# The Sizewell C Project

## 9.11 Responses to the ExA's First Written Questions (ExQ1) Volume 3 - Appendices Part 4 of 7

SIZEWELL C PROJECT -  
RESPONSES TO EXAMINING AUTHORITY'S  
WRITTEN QUESTIONS ISSUED ON 21<sup>ST</sup> APRIL 2021

**DRAWING NO.:**  
 FIGURE 2.8

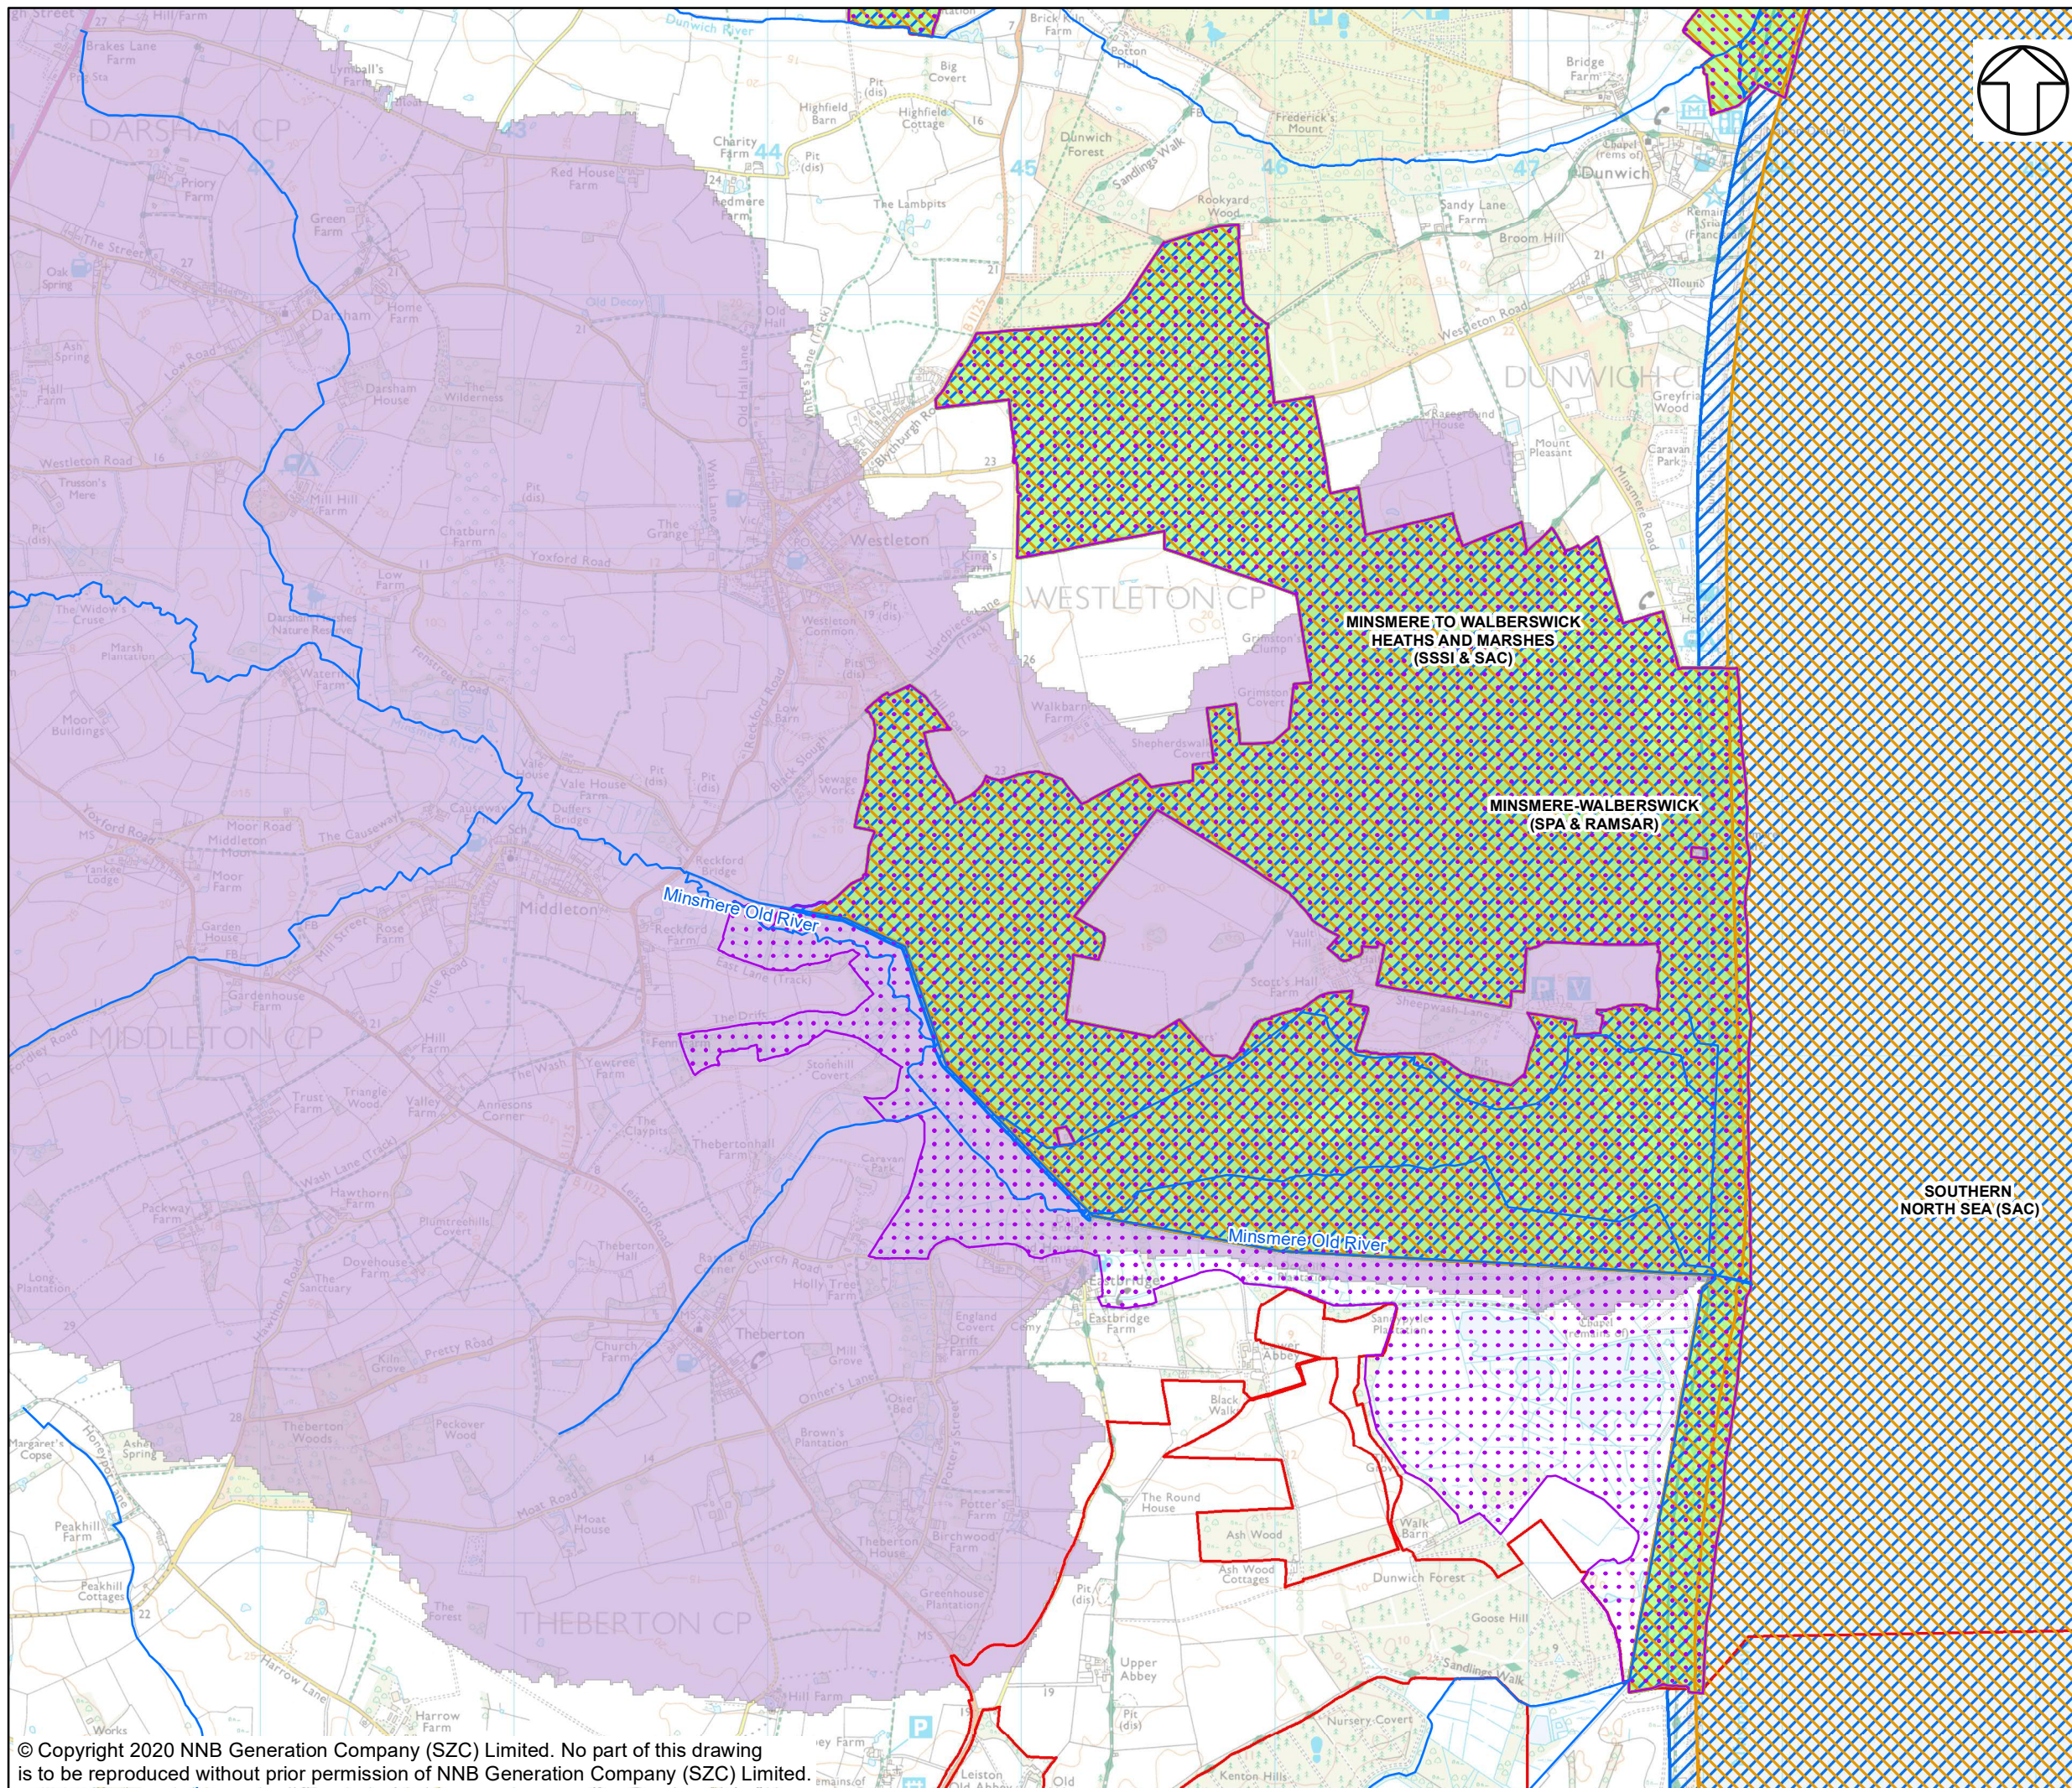
**APPENDIX 15A RESPONSE TO QUESTION FR.1.29,  
UPDATED FIGURE 2.8 OF THE WFD COMPLIANCE  
ASSESSMENT**

DRAWING NO:  
FIGURE 2.9

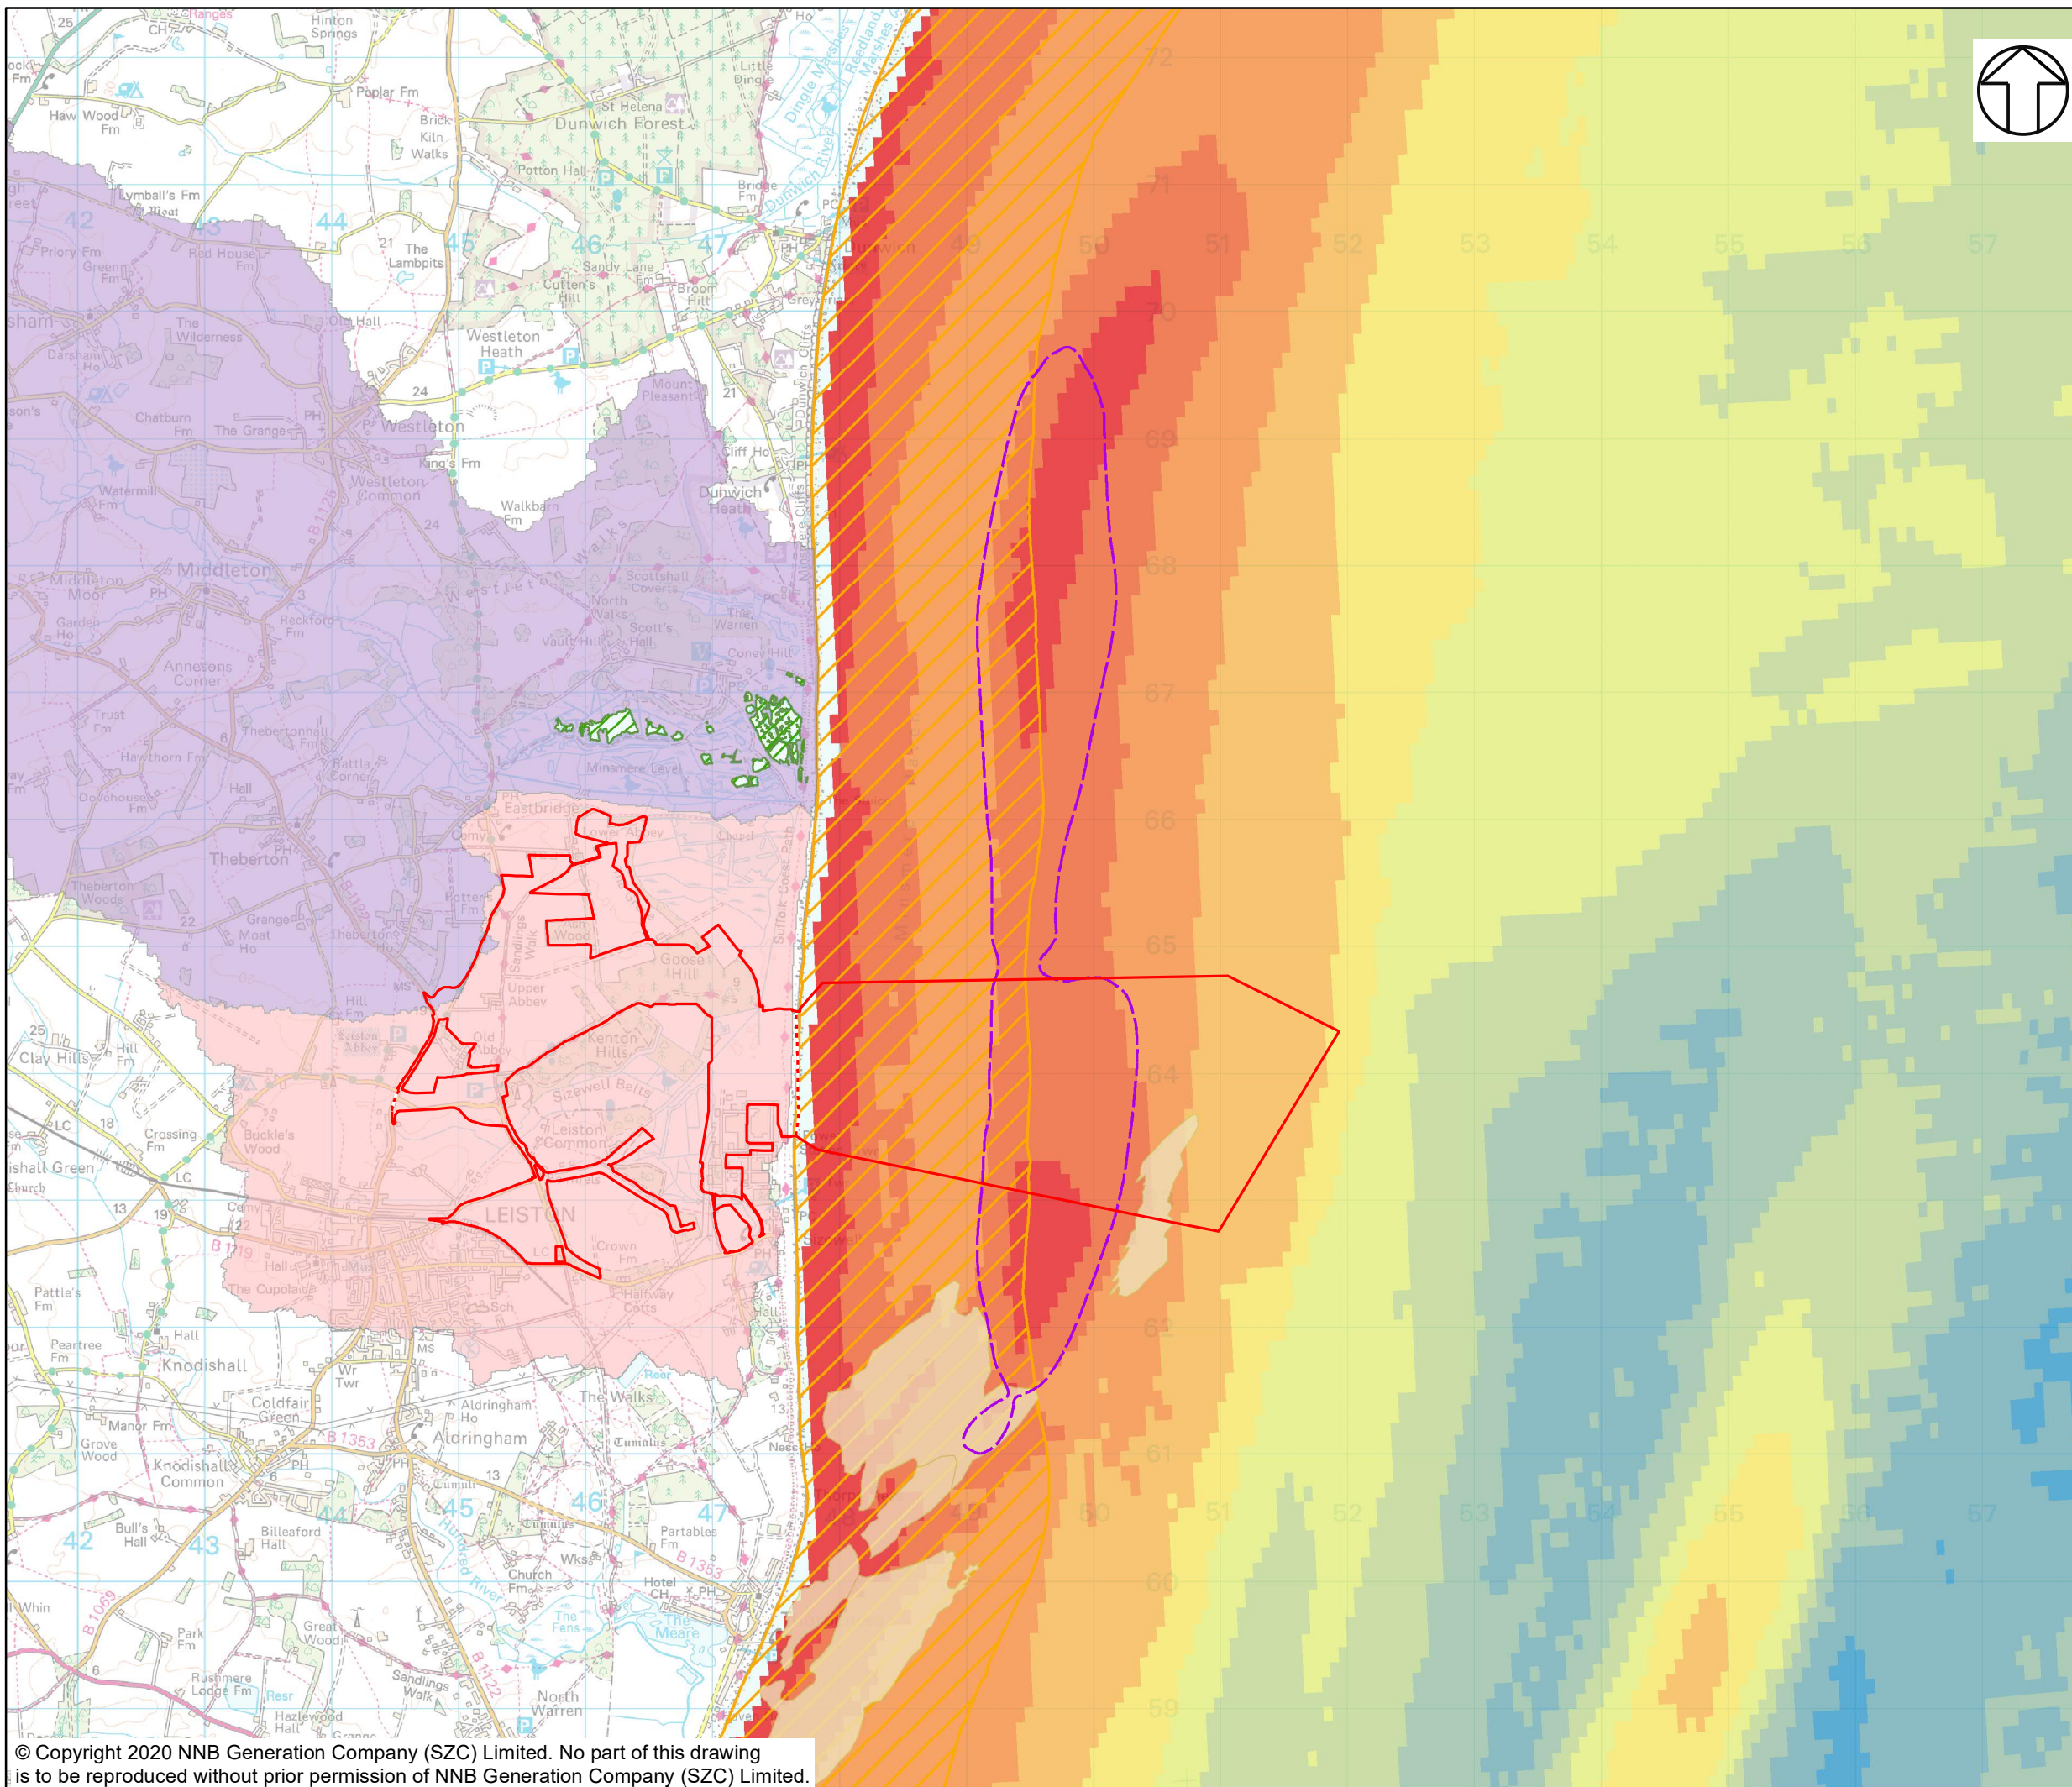
APPENDIX 15B RESPONSE TO QUESTION FR.1.30,  
UPDATED FIGURE 2.9 OF THE WFD COMPLIANCE  
ASSESSMENT
